Intel[®] Pentium[®] 4 Processor Specification Update

Release Date: January 2002

Order Number: 249199-017

January 2002	-017	Added Intel® Pentium® 4 Processor with 512KB cache in .13 micron process information.

The following figure will be added as Figure (new). THERMTRIP# Power Down Sequence

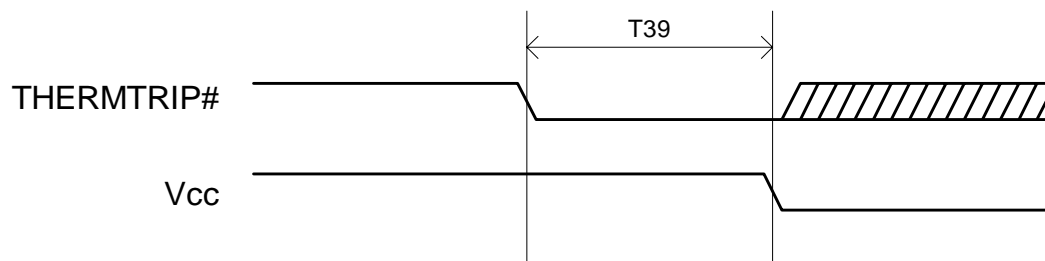
N3. THERMTRIP# Clarification

Several parts of the *Intel® Pentium® 4 Processor in the 423-pin Package* datasheet will be updated as follows to clarify the functionality of the Thermtrip# pin.

The description of THERMTRIP# in Table 32, page 69 will now state:

Assertion of THERMTRIP# (Thermal Trip) indicates the processor junction temperature has reached a level beyond which permanent silicon damage may occur. Measurement of the temperature is accomplished through an internal thermal sensor which is configured to trip at approximately 135°C. Upon assertion of THERMTRIP#, the processor will shut off its internal clocks (thus halting program execution) in an attempt to reduce the processor junction temperature. To protect the processor, its core voltage (V_{CC}) must be removed following the assertion of THERMTRIP#. See Figure (new) and Table 13 for the appropriate power down sequence and timing requirements. Once activated, THERMTRIP# remains latched until RESET# is asserted. While the assertion of the RESET# signal will de-assert THERMTRIP# , if the processor's junction temperature remains at or above the trip level, THERMTRIP# will again be asserted after RESET# is de-asserted.

The following specification will be added to Table 13, page 24.

<u>T# Parameter</u>	<u>Min</u>	<u>Max</u>	<u>Unit</u>	<u>Figure</u>	<u>Notes</u>
T39: THERMTRIP# to removal of power	N/A	500	ms	(new)
